T32MZ SOFTWARE UPDATE CHANGES**(Editor Version: 3.2.1 Encoder version: 1.1)**

1. Fixed a defect on the screen off function.**T32MZ SOFTWARE UPDATE CHANGES****(Editor Version: 3.2 Encoder version: 1.1)****1. Add Screen off function [Quick start]**

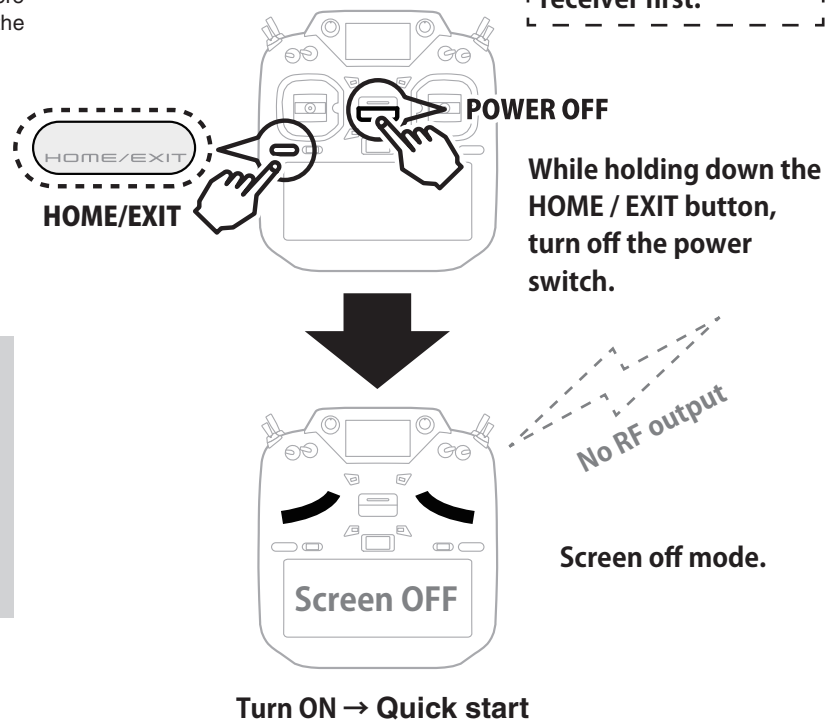
This "screen off" can quick start next startup. This is convenient when turning on and off frequently. No RF output at "screen off". Also, there is no screen display. However, the battery is consumed because the internal circuit is activated.

Be sure to turn off the receiver first.

- ⚠ While in screen off mode, it consumes about 4% of the battery per hour. If you do not use the transmitter for a long time, turn off the power.
- ⚠ Updates cannot be performed in screen off mode. To update, turn off the power.
